Technical Bulletin

Bulletin Number: 195 Revision Number: R-01

SUBJECT: COIN CHUTE ANGLE

MODELS AFFECTED: All Adaptables - Security Door
All Serpentes - Security Door

FIGURE 1

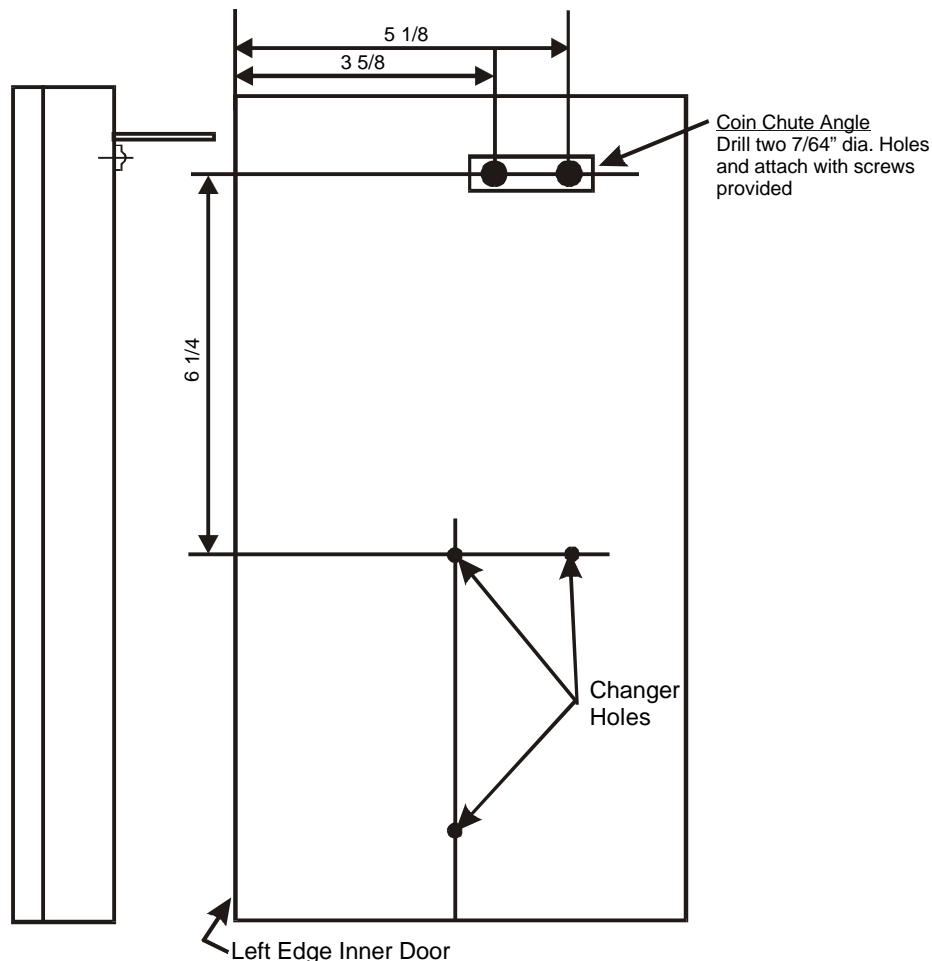
REASON: To provide a support for the coin chute so the back of the chute cannot be pushed out of position from the front of the vender via the coin insert opening.

INSTALLATION: Install as shown in figure 1 on Inner Door.

ORDER AS: 1 - 176,150,21x.x3 Angle, Coin Chute
2 - 900,301,84x.x1 Screw, #8-18x½ Phil Pan AB
